INCH-POUND
MIL-PRF-19500/424D
w/AMENDMENT 1
DRAFT
SUPERSEDING
MIL-PRF-19500/424D
12 February 2021

SEMICONDUCTOR DEVICE, DIODE, SILICON, FAST RECOVERY, POWER RECTIFIER,
1N5186, 1N5187, 1N5188, AND 1N5190,
QUALITY LEVELS JAN, JANTX, AND JANTXV

SUBJECT: Initial Draft of Performance Specification Sheet MIL-PRF-19500/424 Rev D with Amendment 1; Project Number 5961-2026-089.

FIGURE 1. Physical dimensions of DO-41 package.

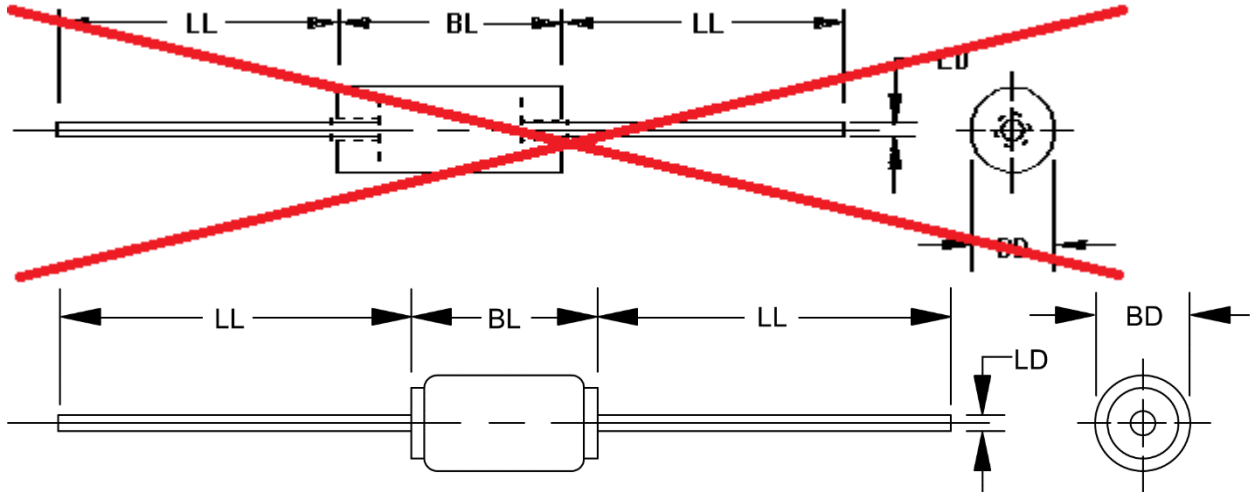
1. Dimensions are in inches. 2. Millimeters are given for general information only.
2. Package contour optional with BD and length BL. Heat slugs, if any, shall be included within this cylinder length but shall not be subject to minimum limit of dimension BD.
3. Dimension BD shall be measured at the largest diameter.
3. The Dimension BL dimension shall include the entire body including slugs. 4. Dimension BL shall include the and sections of the lead over which the diameter is uncontrolled. This uncontrolled area is defined as the zone between the edge of the diode body and extending .050 inch (1.27 mm) onto the leads.
4. The specified lead diameters apply in the zone between .050 inch (1.27 mm) from the diode body
5. In accordance with ASME Y14.5M, diameters are equivalent to ϕ x symbology.
